**CLINTON CREEK**

**INDEPENDENT ENGINEER'S CHANNEL  
ASSESSMENT**

**FINAL**

**Re: Independent Engineer's Channel Assessment, Clinton Creek, Yukon – FINAL**

Figure 3-1. Photos of spillway during commissioning, and two site visits. Flow direction is left to right.

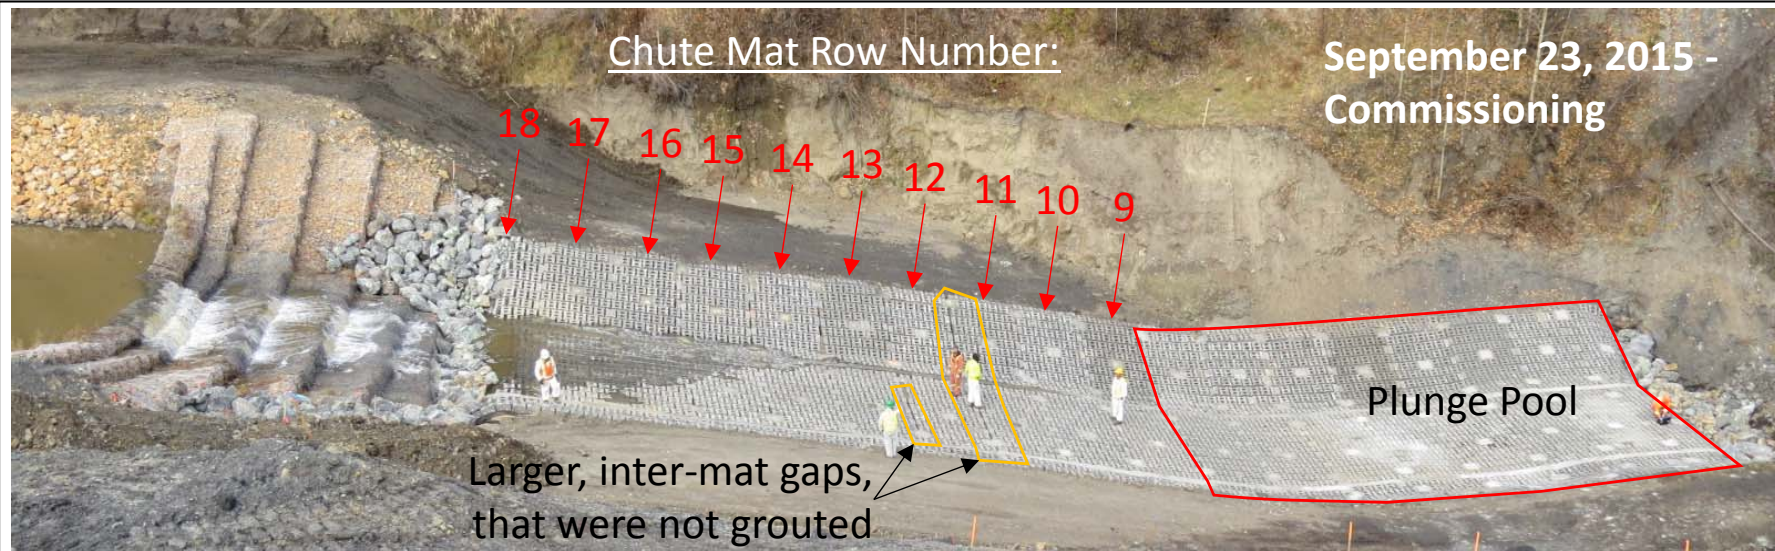
- As shown in Figure 3-1, the chute is comprised of 10 rows of mats and five deformation ripples were observed:
  - a. Between mats in row 11 and 12, the downstream mat (row 11) was observed to be protruding above the upstream mat (row 12) in the centre of the channel. Also, adjacent to the left bank and immediately downstream of the lateral mat connection, highly turbulent flow was observed.

Also shown in Figure 3-1, there appeared to be several other smaller deformities that affected a smaller mat area. These smaller deformities were located on mats 9 and 10.

- As shown in Figure 3-1, Figure 3-3 and Figure 3-4, there were large gaps between rows 11 and 12, and rows 12 and 13, where the mats did not abut one another at commissioning and the gaps were never grouted. Between rows 11 and 12 on the right bank, the geogrid was observed to be bunched, some of the blocks were cracking, and a 10 cm gap was measured at the surface of the blocks. Between rows 12 and 13 on the right bank, the geogrid was observed to be bunched, the site was associated with a geogrid overlap location, and a 6 to 7 cm gap was measured at the surface of the blocks.

**Figure 3-2. Example of grouting of void blocks not flush with adjacent blocks. Flow direction is from right to left.**

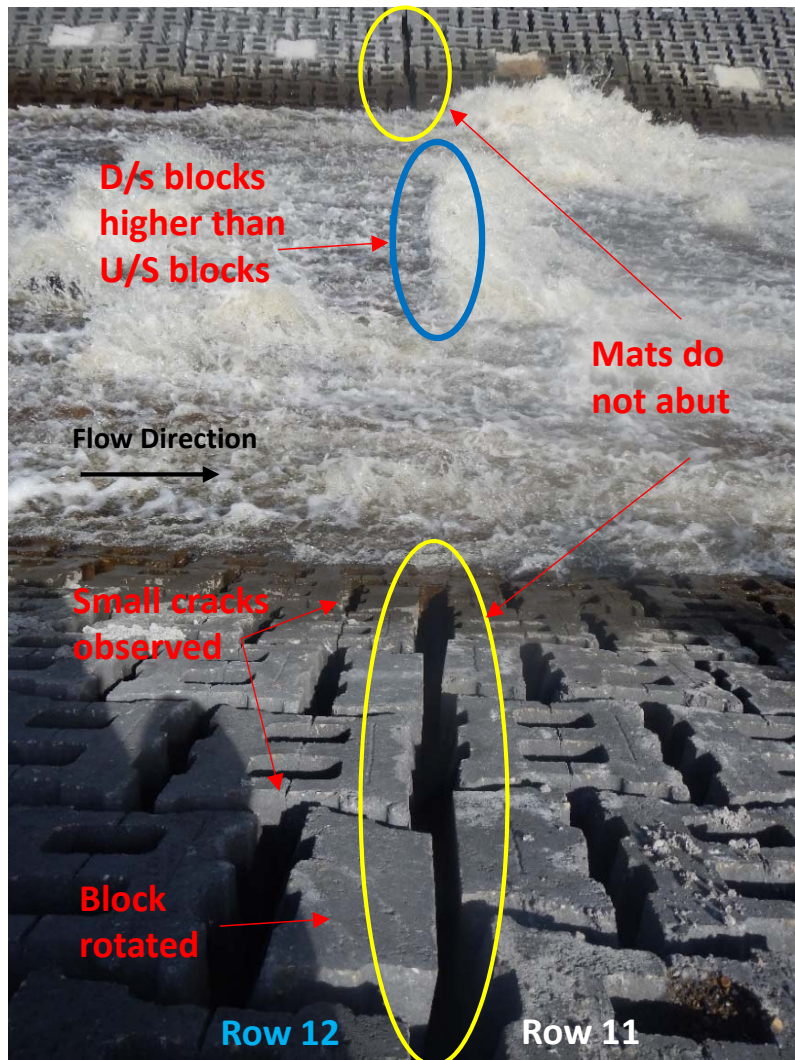
- At the locations where blocks had been excluded from the mat, the voids had been filled with grout; however, the grout was not finished flush with the adjacent blocks. Instead the grout surface was smooth, but angled such that it was approximately 6 cm lower than adjacent blocks in the upslope, upstream corner (Figure 3-2).

- As shown in Figure 3-2, the grout texture suggests that it was likely thick during placement, and therefore, it is unlikely that the grout penetrated both the geogrid and drain rock to seal the holes in the geotextile generated by anchor placement, as per standard practice (ASTM 2015).

**Figure 4-3. Changes in anchor pattern between Issued for Construction (YG AAM 2015a) and Record drawings (Advisian 2015).**

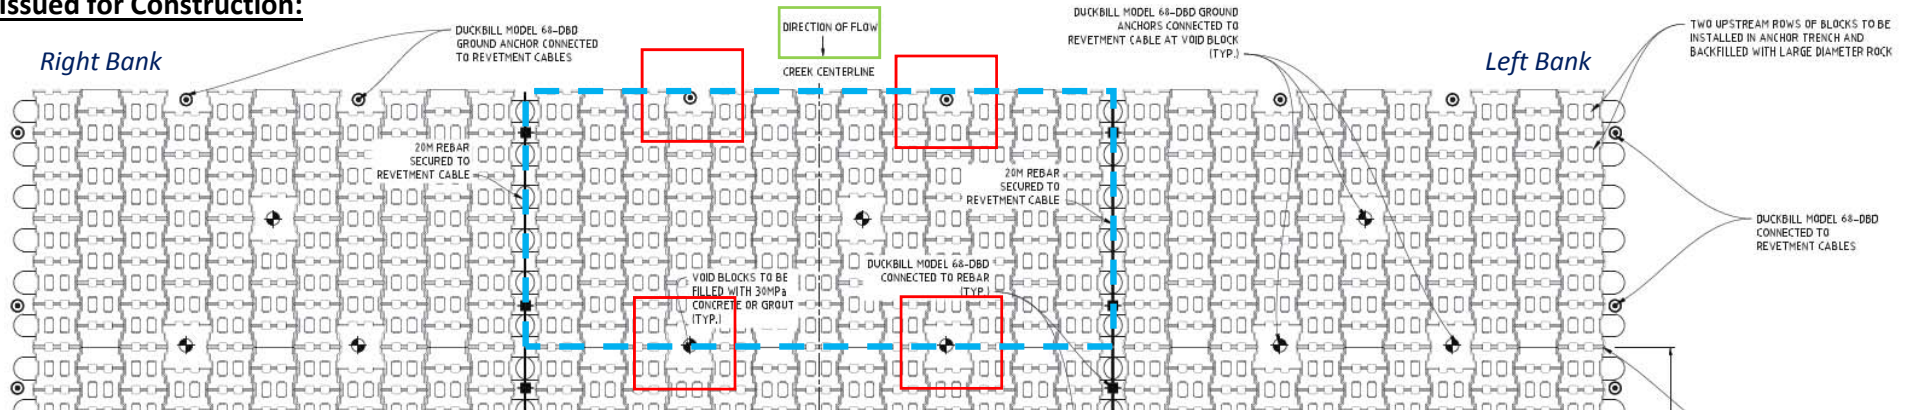
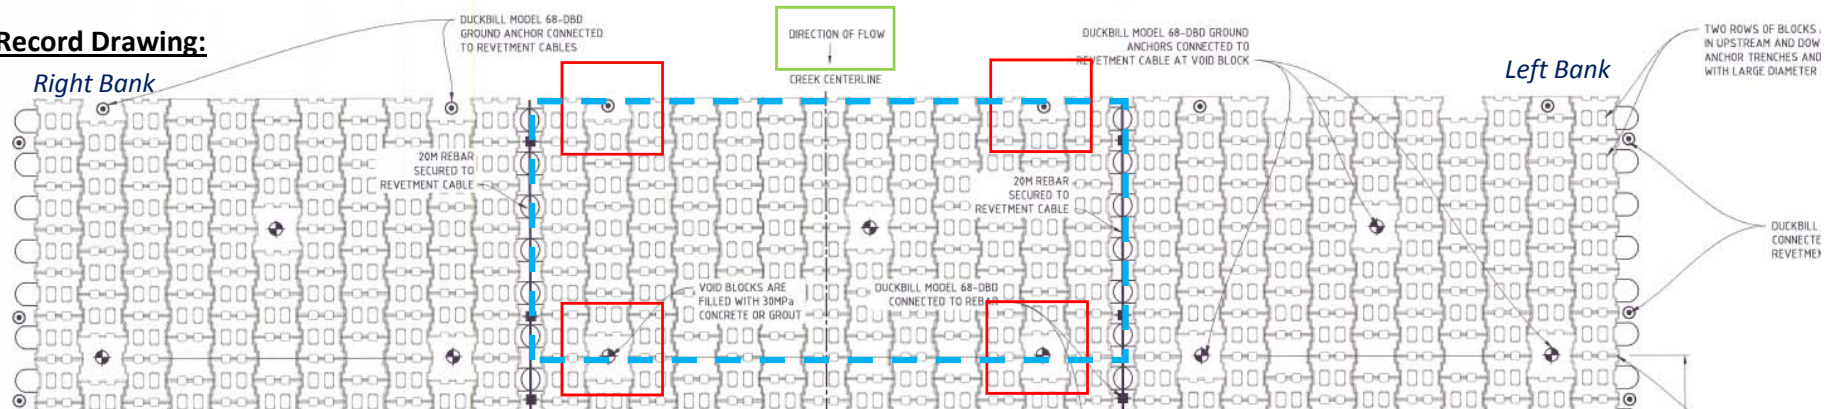
**Anchors as constructed are less centered.**

As designed, each mat was to be anchored at 9 locations. However, the holes for the anchor placements were located incorrectly in both the rejected delivery of 170 mm thick mats (rejected for their incorrect thickness) and the accepted 190 mm mats (YG AAM 2015b). As shown in Figure 4-3, this change in anchoring pattern moved the mat to mat connection anchors at the upstream and downstream ends of each mat towards the banks by approximately 0.9 m for each anchor. This resulted in:

Based on the data provided, this change in anchor layout appears to have originated sometime between when the construction drawings were issued on July 3, 2015 by WP, and when the mats were manufactured. The Armortec Canada drawings shown in the WP construction report appendix for material construction specification data sheets (Advisian 2015) have a revision date of July 27, 2015, and show an anchoring plan that is partly as per the construction drawings, partly as per the record drawings and partly neither. The Armortec drawings are provided in Appendix A. In the information provided to BGC by YG AAM, there is no information to explain which anchor layout design the manufacturer was given.

**Figure 4-4. Factor of safety sensitivity analysis for block projection height.**

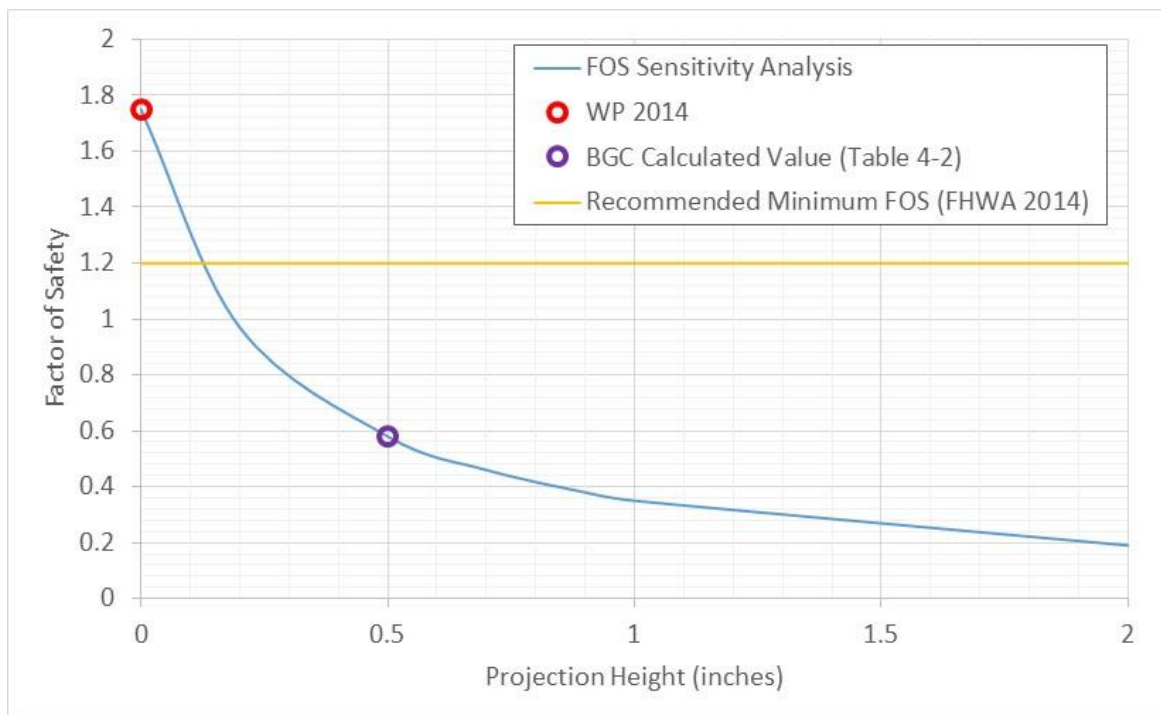
The results of the analysis show a factor of safety against block overturning of 0.6, which implies that individual blocks under design flow conditions, and elevated 0.5 inches into the flow<sup>12</sup>, would be unstable and subject to movement and rotation.

The block stability design software output report shows a Factor of Safety of 1.8. When no projection height is used, BGC obtains similar results. Figure 4-4 shows that the block stability is very sensitive to projection height, particularly between 0 and 0.5 inches. The block stability software output report (WP 2014) suggests to BGC that WP selected the block type using inappropriate input assumptions by selecting no projection height (value of zero).

The hydraulic stability calculations by BGC indicate that the mat design may not be adequate for the design flows, thereby magnifying the impact of changes between the design intent and construction.

**Figure 4-5. Armorflex Tapered Series Block. (Contech 2012).**

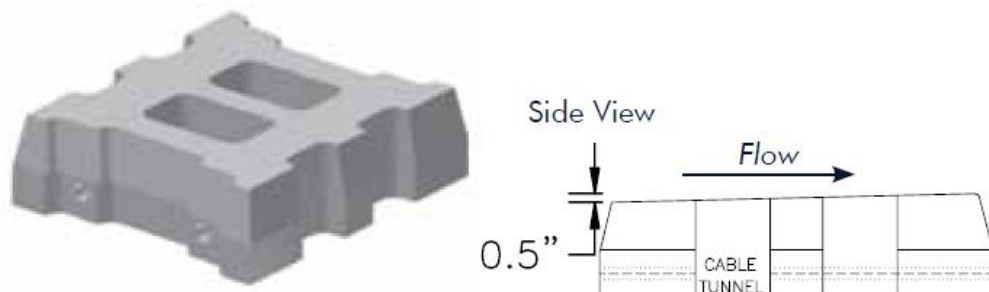
The supplier stresses that the tapering of the blocks is important to the stability of the blocks in high velocity flows. For the benefit of block tapering to be realized, the blocks must be placed in the correct orientation to flow direction and on a perfectly smooth drain rock/subgrade layer so that the blocks align with a 0.5" (1.3 cm) offset, as shown in Figure 4-5.

This last statement is incorrect – as shown in Figure 4-5, the blocks are to be installed with the taper on the upstream side. A spot check of YG AAM construction monitoring photos show the marker lines on the downstream side. The supplier was contacted by BGC to confirm whether the

**Figure 4-6. Close up view of the left bank of mat row 11 and the highly turbulent flow immediately downstream of the lateral mat connection. Photo taken July 19 2016 (YG AAM 2016a).**

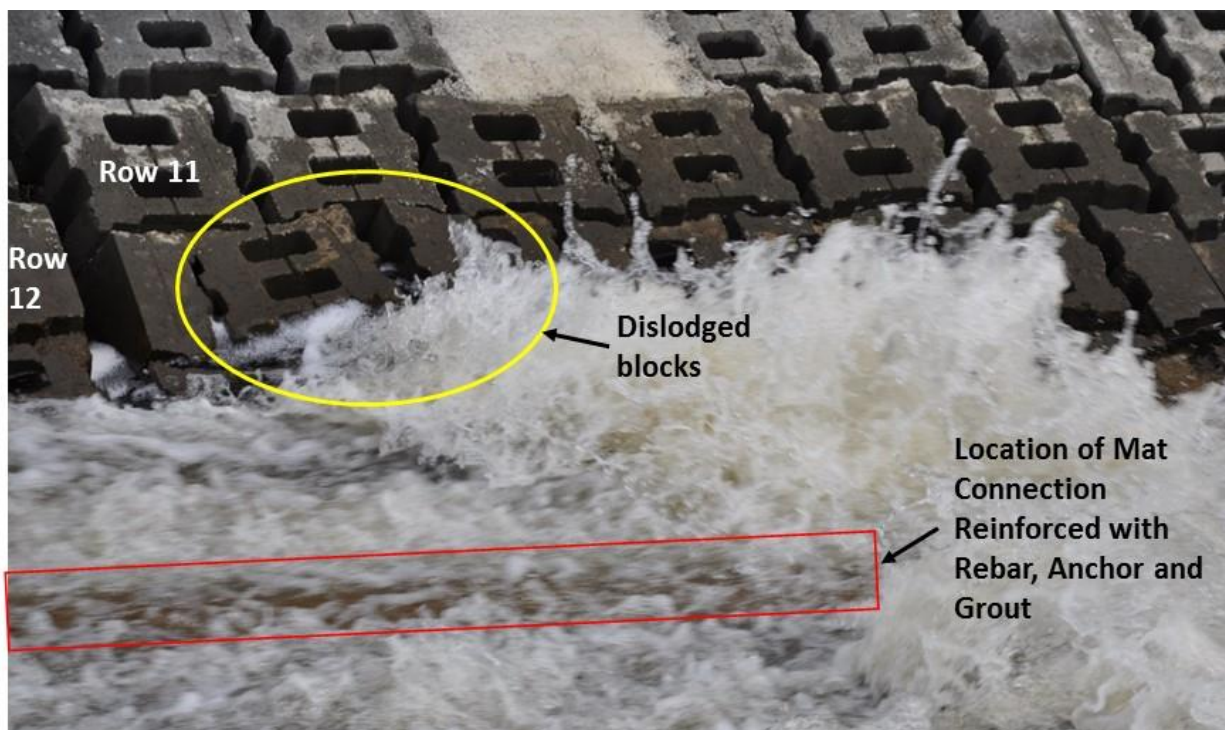
Figure 4-6 shows a close up view of the left bank of mat row 11 and the highly turbulent flow immediately downstream of the lateral mat connection. The photo shows two dislodged blocks on the bank and that the rebar/anchor/grout connection appears intact. The record drawings show that the mat is anchored both immediately upstream, and upstream and to the right, of the turbulent flow. The photo suggests that the anchors are intact. Therefore, the turbulence is likely not a result of changes in anchor placement or anchor failure.

However, the turbulence could be associated with the large mat separation which was observed on both banks and is visible on the chute invert in the construction photos. During commissioning, water flow was directed initially to the left bank, so possibly there is a greater concentration of flow on the left bank than on the right bank. In addition, the upstream mat deformities also help to concentrate flow on the banks.

The construction specifications required: mat seams with openings larger than 5 cm to be grouted and mat seams with a grade change to be grouted (YG AAM 2015a).
